20477-R01-C

47 Peter Street, Manchester

Stage 4 acoustic design report

Figure 2 Proposed roof build-up

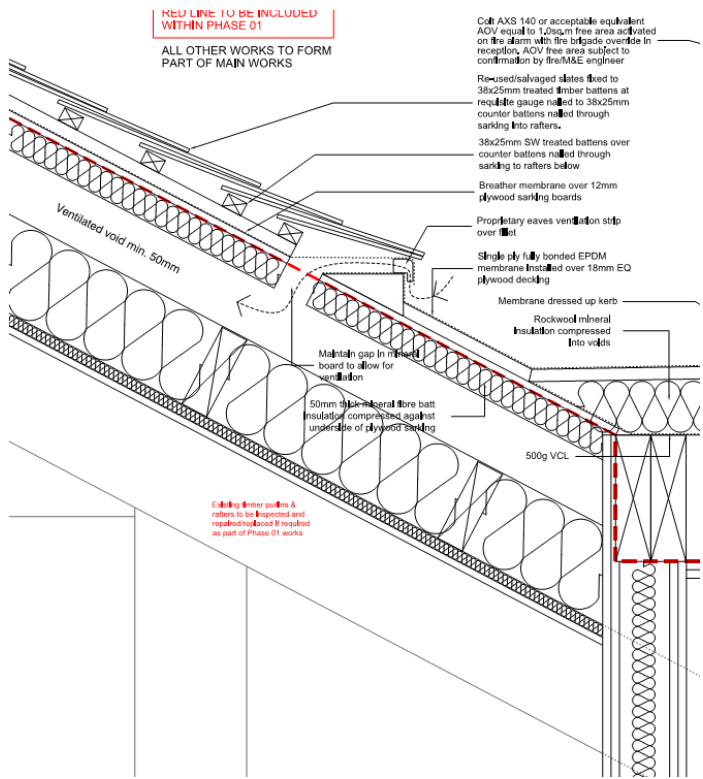
This roof construction is expected to be capable of providing a sound insulation performance in the region of R_w+C_{tr} 40 dB on the basis it is well-sealed.

To enhance the sound insulation performance of the roof to meet the minimum airborne sound insulation requirements to control environmental noise ingress, and help control flanking 15 mm thick SoundBloc (or equivalent) should be provided to the room-side, fixed to the underside of insulated plasterboard lining. It is understood that this is proposed although not shown on the drawing above.

Figure 3 Roof void ventilation detail

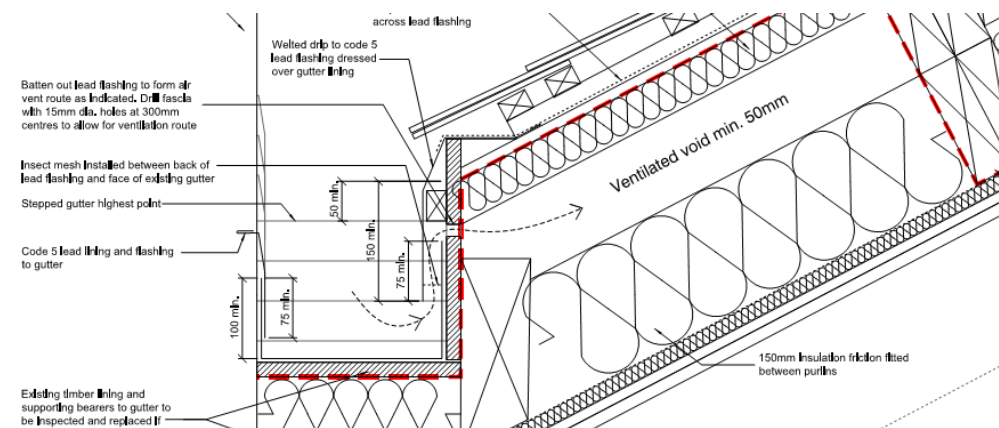
The roof void is to be ventilated via vents in the roof construction, as shown in Figure 3. Noise ingress via these vents will need to be suitably controlled, particularly if located near the rooftop plant area. Ideally, these vents should be sealed if at all possible.

In addition, these vents should not be located near the rooftop plant area in order to limit noise ingress via the vents.

Figure 4 Plant deck external wall

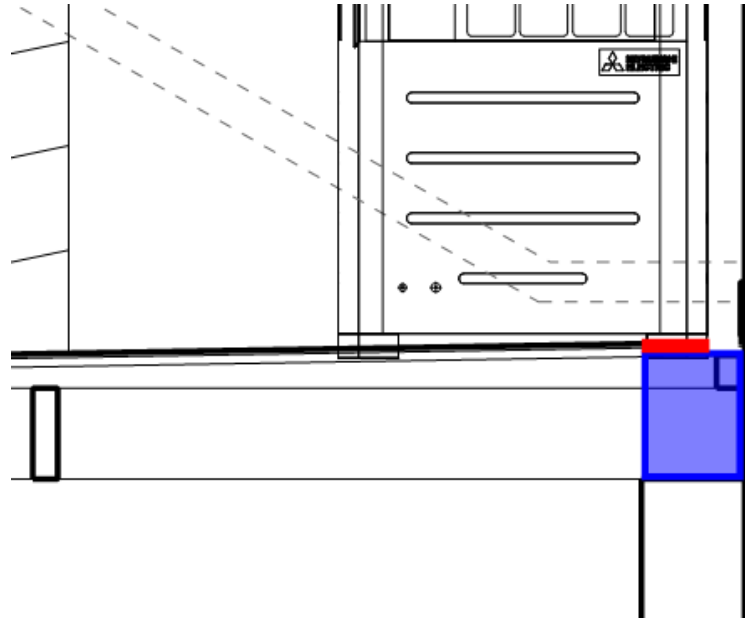
Details of the roof build-up below the plant area have not been received. It is understood that a new timber plant deck is proposed spanning between the roof structure and the external wall construction will be extended to support it (as shown in Figure 4 highlighted in blue). As such, it will be fully independent from the neighbouring building.

The overall roof build-up below the plant area shall provide a minimum sound insulation performance of $R'_w + C_{tr}$ 50 dB. The following build-up is capable of providing this:

Figure 6 Potential void above plant room

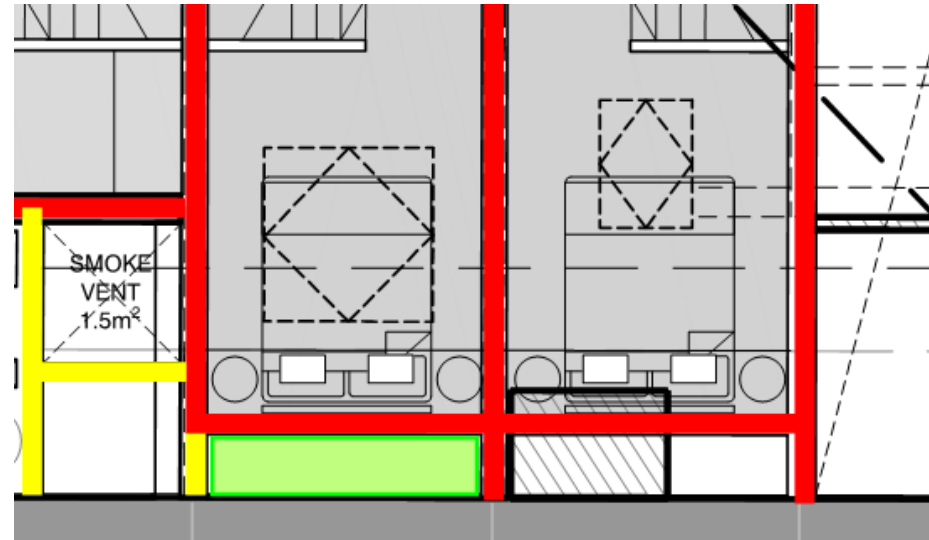
It should be noted that all voids above plant rooms should be closed off. A screengrab of a potential void above a plant room is shown in Figure 6 highlighted in green.

Figure 7 Mezzanine party wall / roof junction detail

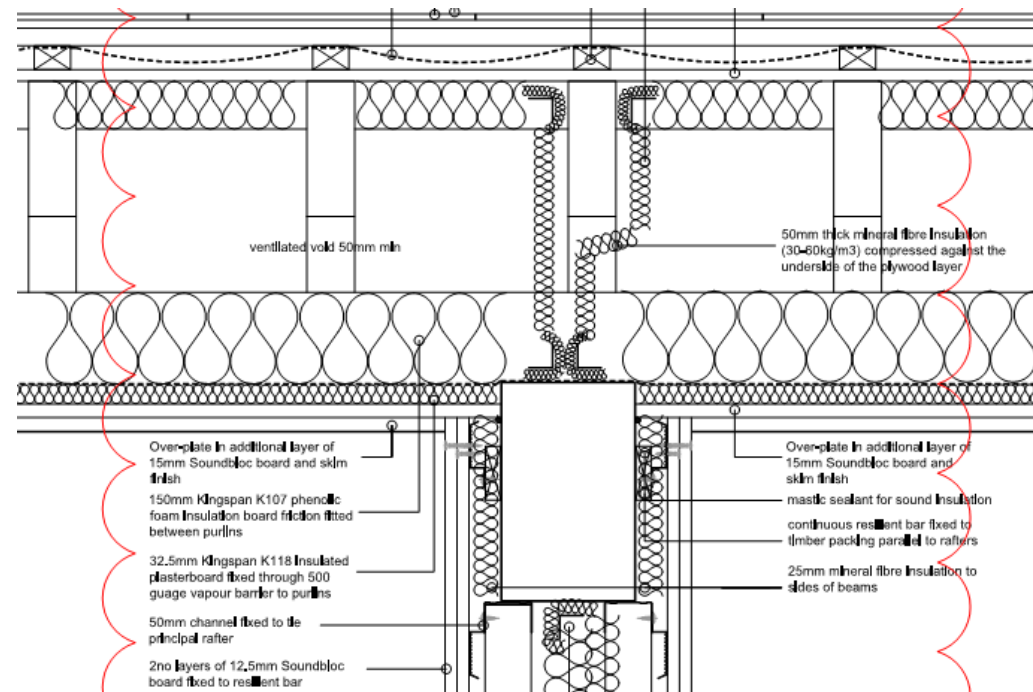
This detail is expected to be capable of controlling flanking via the roof void on the basis it is well-sealed and the void barriers are appropriately selected.

Figure 8 Mezzanine floor / guestroom party wall junction

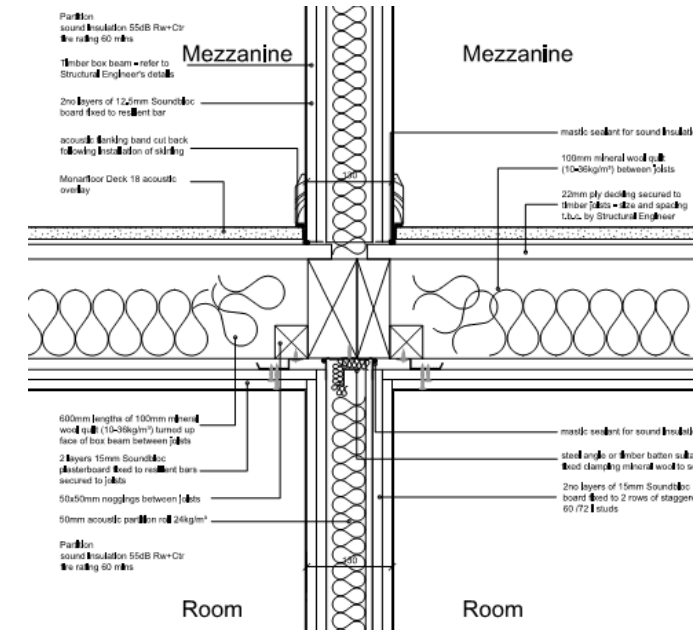
This detail is expected to be sufficient to control flanking between rooms via the floor/ceiling void.

Figure 9 Guestroom beam and partition base detail

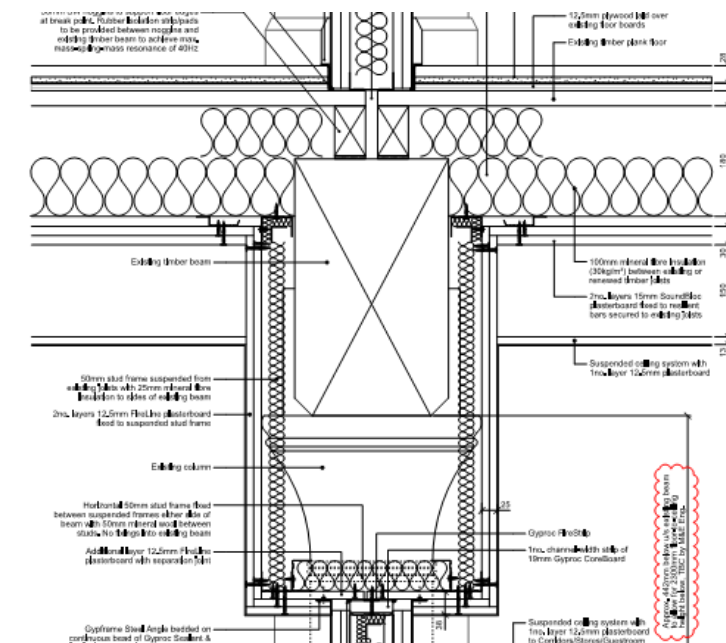
Beams are proposed to be boxed-in for fire purposes with 2 x 12.5 mm Fireline, as per the detail shown in Figure 9, which is a typical detail for a guestroom to guestroom adjacency.

The proposed beam detail is expected to be capable of achieving the sound insulation performance requirement of $D_{nT,w}+C_{tr}$ 43 dB between guestrooms.

Figure 10 Mezzanine party wall with exposed truss

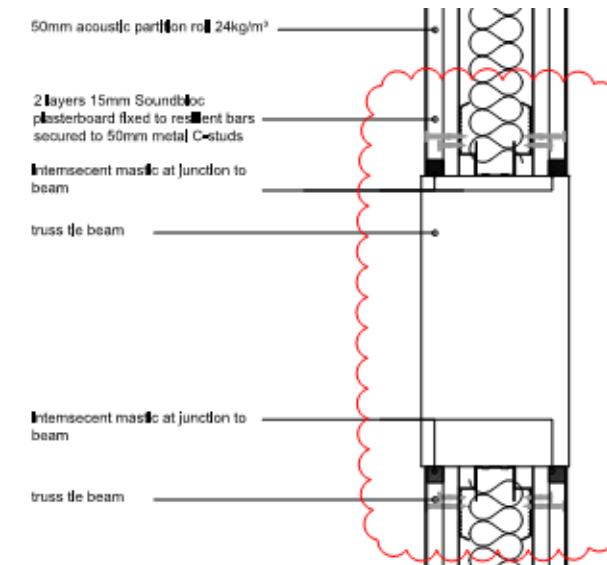
It is understood that at the third floor mezzanine level, timber trusses form part of the guestroom party walls and are to be exposed for conservation purposes as per Figure 10.

Shortfalls of approximately 3 dB are predicted for the sound insulation performance of party walls due to the exposed trusses. Any gaps between boards and the trusses should be no more than 12 mm and sealed with a non-setting acoustic mastic. If any deflection joints are needed, metal cover plating would need to be included.

Figure 12 Boxing in of existing columns

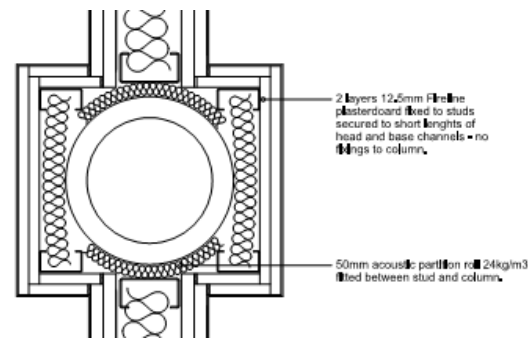
This detail is acceptable from an acoustic perspective when proposed between guestrooms.

Figure 14 Communal space ceiling and exposed beam detail

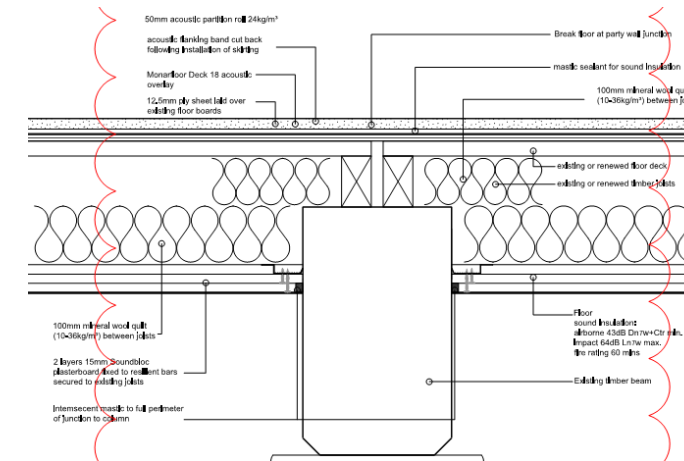
The exposed beam detail for communal spaces is shown in Figure 14. This is suitable from an acoustic perspective on the basis that it is only proposed between communal spaces.

Figure 15 First floor secondary glazing section detail

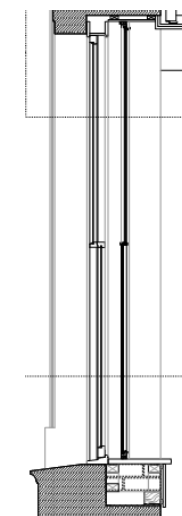
A section of the first floor glazing is shown in Figure 15, similar details are proposed to the other floors. This detail appears suitable from an acoustic perspective. It will need to be ensured that the combination of primary and section glazing achieve the facade sound insulation performances previously set out.

Ideally manufactures data should be provided for the proposed secondary glazing systems with predictions made for the systems in combination with the existing primary glazing.

Figure 17 Rooftop plant and item locations (Excerpt from 3278-AER-XX-Z-DR-M-5302 plant space services layout)

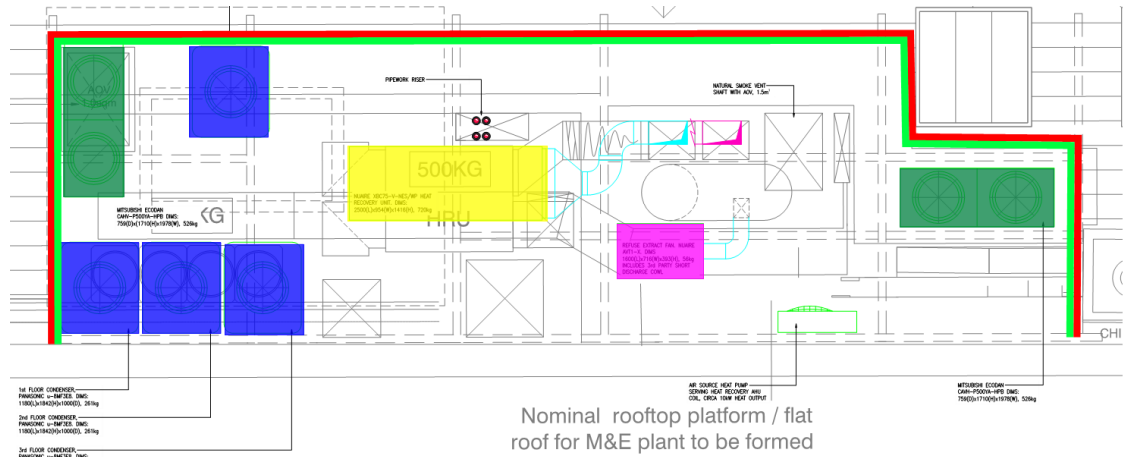
Acoustic screening is proposed to the south, west and north of the roof top plant. Based on the M&E layouts and comments from the architect, the screening is proposed to be 2m high above the deck level and indicated in red in Figure 17.

3 dBA of attenuation is required to the discharge termination of the Nuair XBC75-V-NES (HRU). This could be provided by a rectangular elbow internally lined with 25 mm sound absorbent material, or 1m long ductwork with 25mm sound absorbent material could provide this or a proprietary 600 mm attenuator.

In addition, it is recommended sound absorbent lining with minimum α_w 0.9 (typically 50-100 thick) be provided to the inner face if the acoustic screen to control reverberant noise build-up and reflections within plant area as indicated in light green in Figure 17. The screen should be solid with a minimum weight of 15 kg/m².

Figure 18 FCU testing arrangement

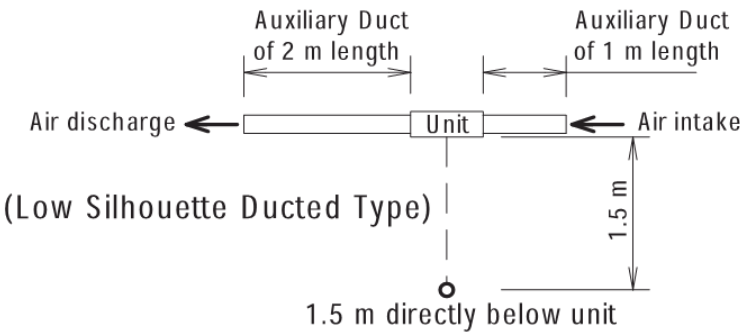
The sound pressure data provided is for the FCU intake / supply and casing breakout noise together. The test arrangement for the S-28MM1E5A is shown in Figure 18.

In order to more accurately assess noise emissions from the FCUs, ideally separate noise data should be provided for each FCU noise source.

Figure 19 Plant room locations

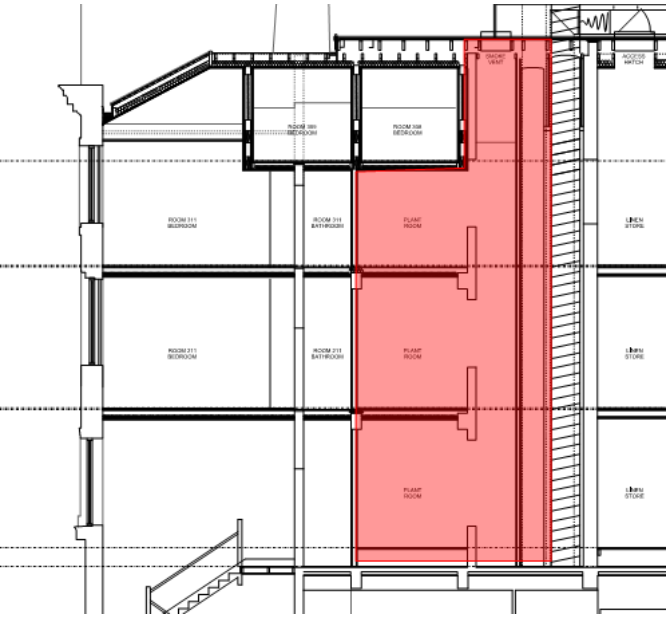
It is understood that plantrooms are to be located adjacent to guestrooms as highlighted in red within Figure 19.

It is not entirely clear what the plantroom arrangement will be (as it appears that they are currently continuously open to the smoke vent, from level 1 to roof level). This will need to be clarified as the design progresses.

Figure 21 Rooftop plant and item locations (Excerpt from 3278-AER-XX-Z-DR-M-5302 plant space services layout)

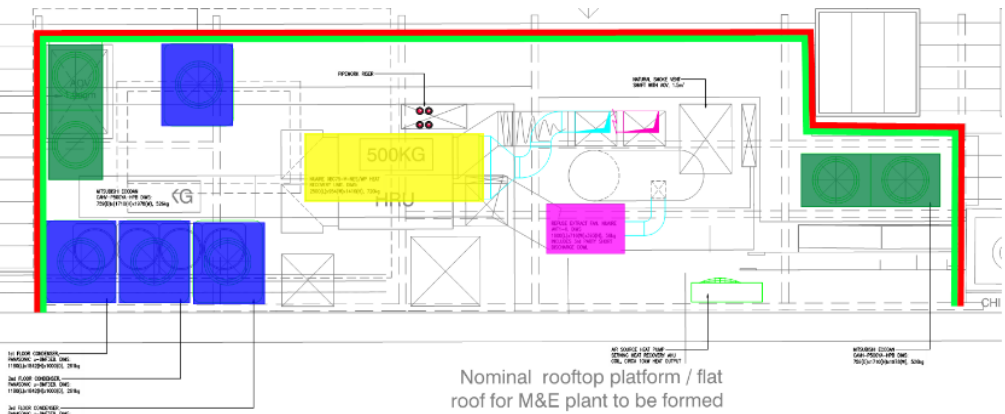
In order to control noise emissions from the HRU supply / extract, in-duct attenuators will be required. Attenuators are currently shown on the rooftop plant layouts. Minimum insertion losses required by these attenuators are provided in Table 17.
